1.4.6 Ringer R08.

TITLE: ROT RINGER MODIFICATION

SIZE	CODE IDENT NO	DRAWING NO
C	33967	3-157446

1 2 3 4 5 6
CKT. SIDE

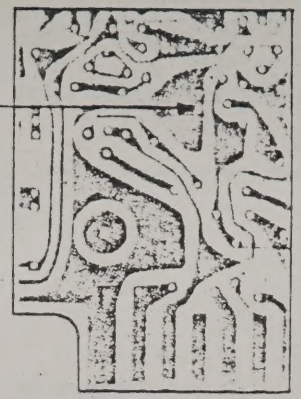
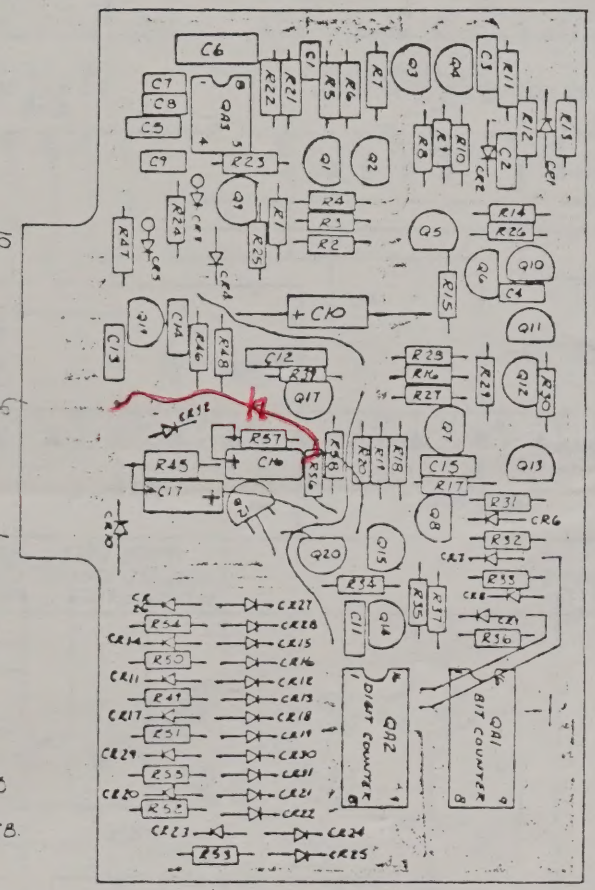
DRILL 1(ONE) .031 HOLE FOR R57 ON REV C & D BDS.

COMP. SIDE

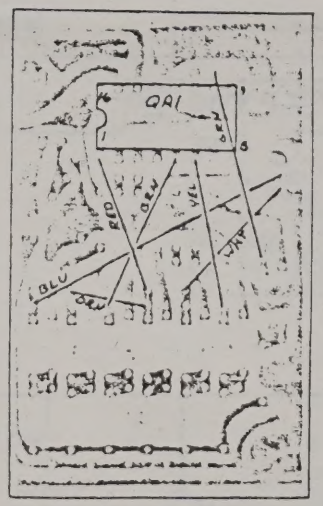
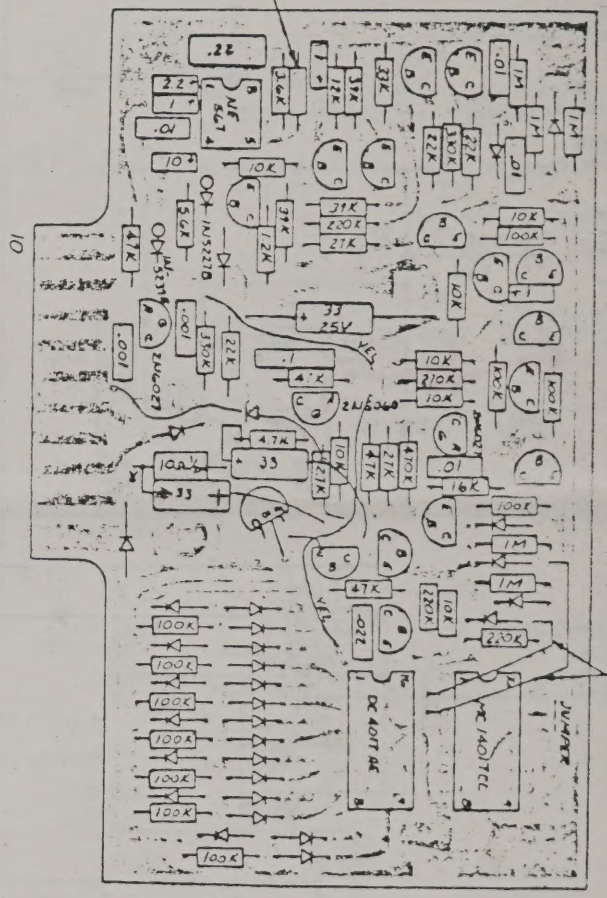
ADD DIODE ON BOTTOM SIDE OF ROT BOARD
